**Date : 4/27/2021 5:04:56 PM**  
**From : "Pete Eyre"**  
**To : "Wes Pringle"**  
**Subject : 6450 West Sunset Blvd - Letter Ready for Review**  
**Attachment : [DRAFT]\_CEN20-49786\_6450 Sunset Blvd\_MU.pdf;**

6450 West Sunset Boulevard  
DOT Case No. CEN20-49786

Subject: **TRANSPORTATION ANALYSIS FOR THE PROPOSED MIXED-USE PROJECT LOCATED AT 6450 WEST SUNSET BOULEVARD (CPC-2020-1929-HD-VCU-MCUP-SPR-RDP-WDI/ENV-2020-1930-EIR)**

Figure 2

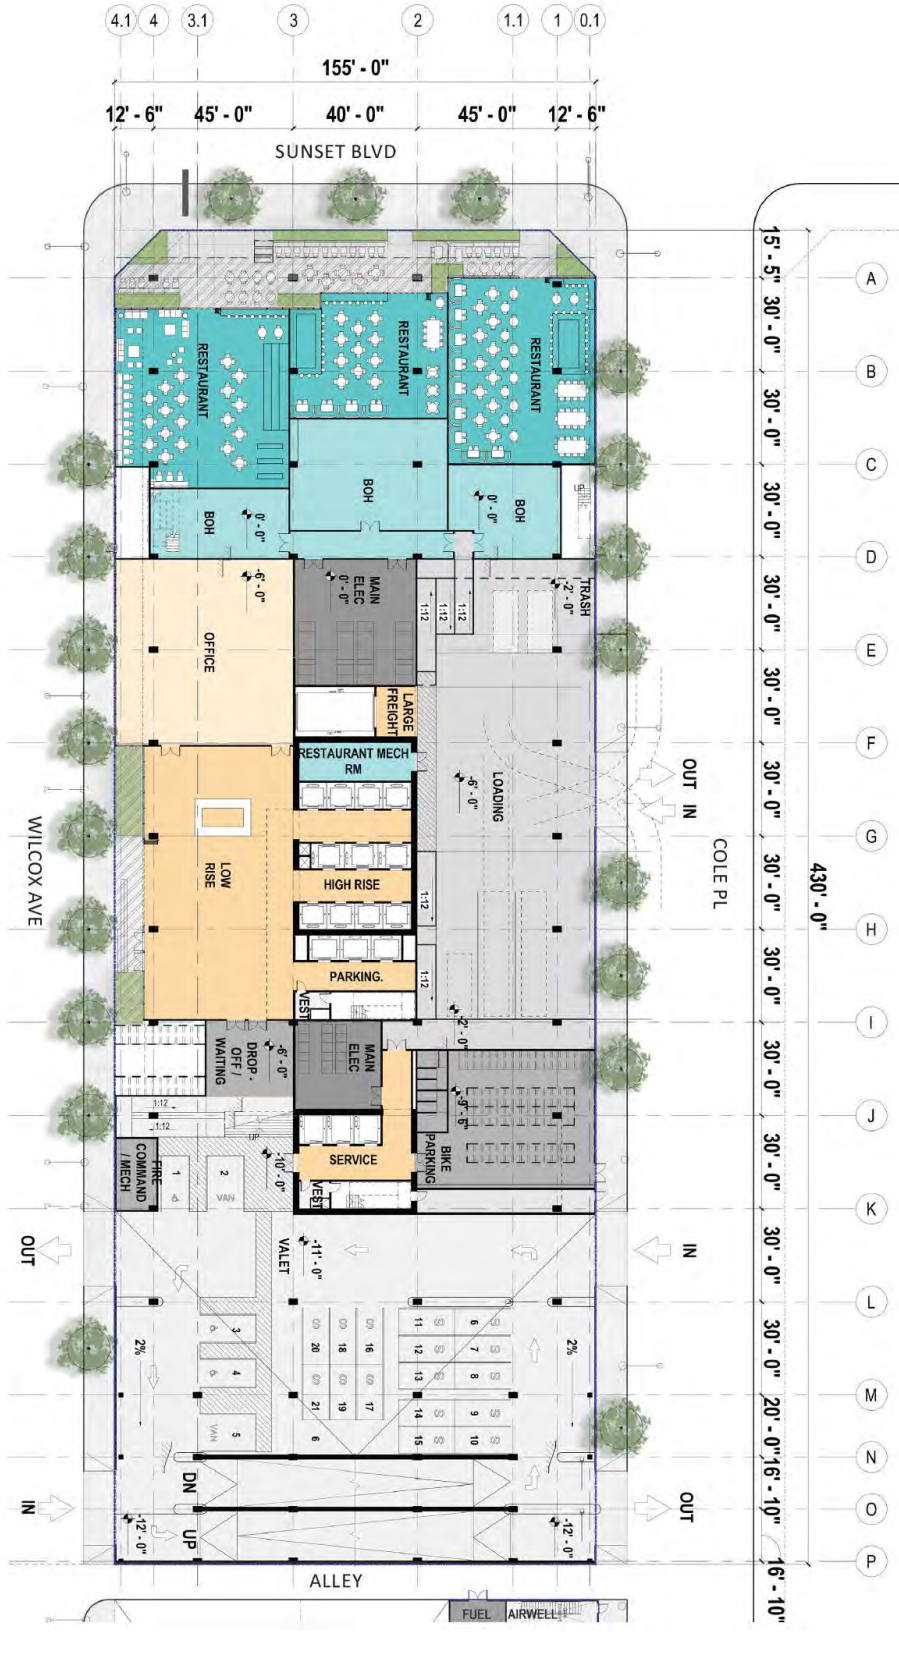
The conceptual site plan (see **Attachment D**) is acceptable to DOT. Vehicular access to the site will be provided via six total driveways: four on Cole Place and two on Wilcox Avenue. The four Cole Place driveways include: one ingress driveway, one egress driveway, one two-way driveway for loading operations, and one driveway exclusively for LADWP access to the site. The two Wilcox Avenue driveways include: one ingress and one egress driveway. Bicycle parking access to the site will be located on Cole Place. Pedestrian access to the site will be located on Sunset Boulevard and Wilcox Avenue. However, the review of this study does not constitute approval of the dimensions for any new proposed driveway. This requires separate review and approval and should be coordinated with DOT's Citywide Planning Coordination Section (201 N. Figueroa Street, 5th Floor, Room 550, at 213-482-

7024). In order to minimize and prevent last minute building design changes, the applicant should contact DOT for driveway width and internal circulation requirements prior to the commencement of building or parking layout design.
